## **City of Gainesville**

## Memo

Re: GeoTrans, Inc. - Fencing and Signage West of Former Koppers Site, August 19, 2010

## Exhibit B

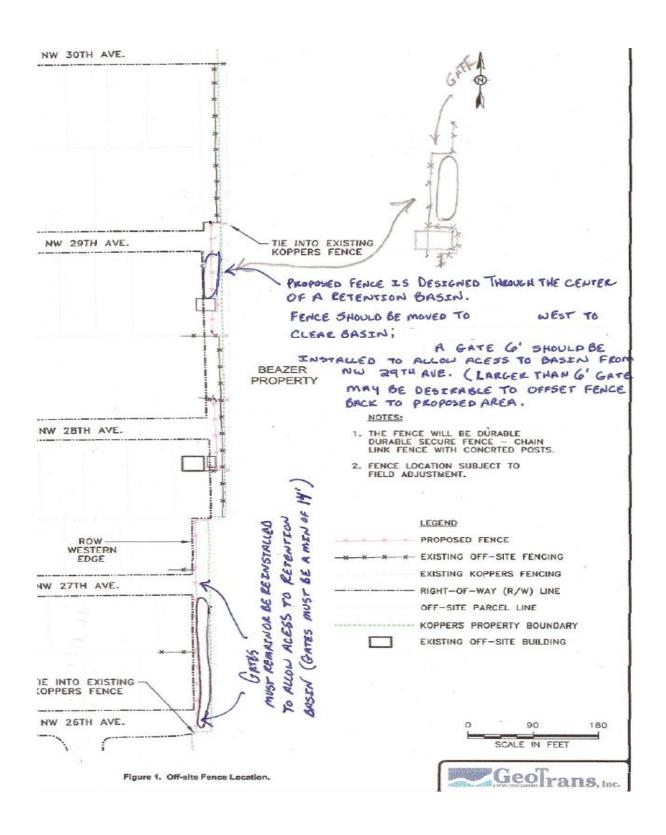
- 4. Segment 1-2, Gates 1 & 2 are needed to provide equal access for maintenance activities. They should have locking mechanisms and be equal in width to the existing gates. The existing gates are to removed and stored in the protected area. It is assumed that the new fence will be installed close, within 2 feet, to the westerly ROW. See exhibit B for more details.
- 5. Segment 2-3, The City prefers to have the new fence continuous between the two segment references and close to the Westerly ROW as described above.
- 6. Segment 3A-5A, The City prefers to have the new fence continuous between the two segment references and close to the Westerly ROW as described above.
- 7. Segment 5B-6, The City prefers to have the fences as far west as possible while still allowing the residential use as it exists today. See exhibit B for details.
